PETITION NO:	Z-23
HEARING DATE (PC):	03-01-16
HEARING DATE (BOC)	: 03-15-16
PRESENT ZONING:	R-30
PROPOSED ZONING: _	RSL
PROPOSED USE: Se	enior Residential
	Development
SIZE OF TRACT:	7.92 acres
DISTRICT:	20
LAND LOT(S):	120
PARCEL(S):	20, 26
TAXES: PAID X	DUE
COMMISSION DISTRIC	C T: _1

APPLICANT: Paulding Const	ruction Solutions	PETITION NO.:	Z-23
PRESENT ZONING: R-30		PETITION FOR:	RSL
* * * * * * * * * * * * * * * * *	* * * * * * * * * * * * * * *	* * * * * * * * * * * * * * *	* * * * * * * * *
ZONING COMMENTS:	Staff Member Responsib	le: Jason A. Campbell	
Land Use Plan Recommendat	ion: Rural Residential (0	-1 unit per acre)	
Proposed Number of Units:		Density: <u>3.54</u>	Units/Acre
Staff estimate for allowable # *Estimate could be higher or lower b			its/Lots e of property, utilities,

Z-23 PAULDING CONSTRUCTION SOLUTIONS

Z-23

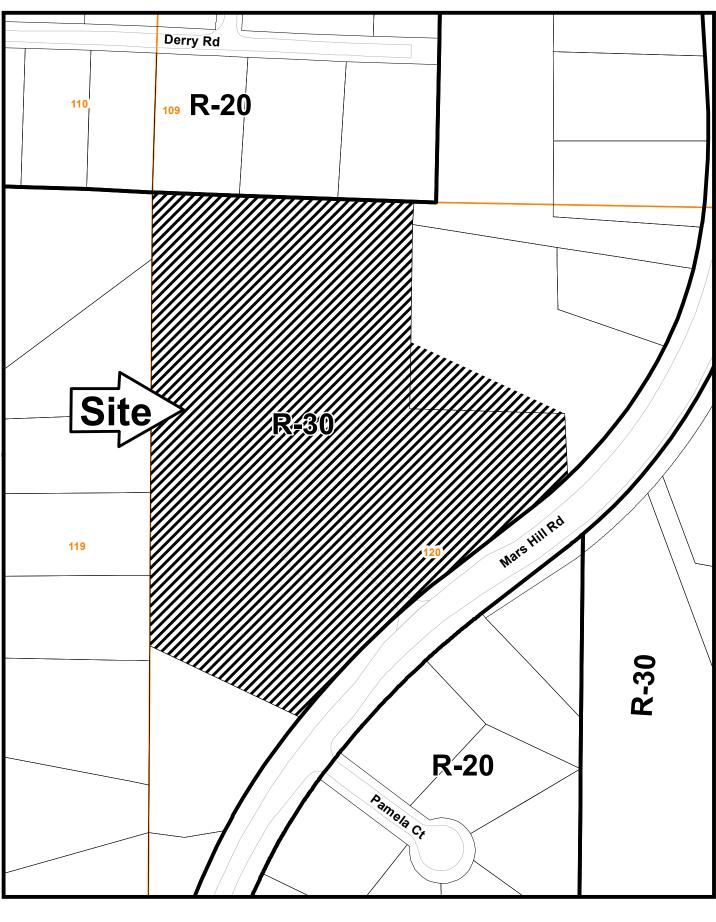
No Stormwater controls shown

- Copy of survey is not current Additional comments may be forthcoming when current site conditions are exposed.
- No site improvements showing on exhibit.
